**REQUEST** Current Zoning: B-1(CD) (neighborhood business, conditional)

Proposed Zoning: UR-2(CD) (urban residential, conditional)

**LOCATION** Approximately 13.01 acres located at the southeast intersection of

Petition 2019-062 (Page 3 of 8) Final Staff Analysis

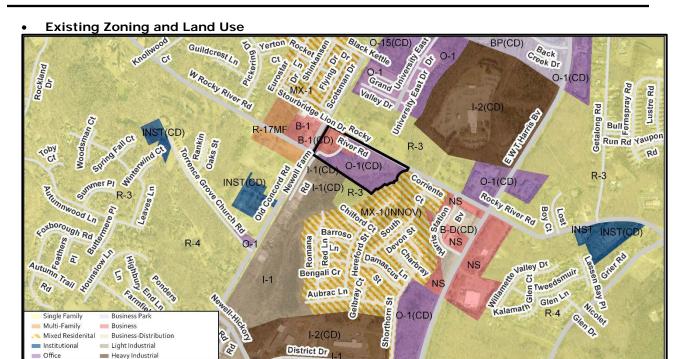
- Develops site with a planned multi-family development containing a maximum of 126 duplex units.
- Provides driveway connections to Rocky River Road and constructs a new public street (designated as the University East Collector Road on the rezoning plan).
- Limits the maximum height to 1.5 stories and requires architectural design standards.
- Constructs an 8-foot wide planting strip and 6-foot sidewalk along the site's frontages on Rocky River Road and the University East Collector Road.
- Establishes a minimum 37.5-foot Class A buffer along the Site's southern boundary. The required width of this buffer has been reduced by 25% from 50 feet to 37.5 feet by installation of a berm.
- Dedicates and conveys the 100-foot SWIM buffer of Back Creek located on site to Mecklenburg County for future greenway purposes.
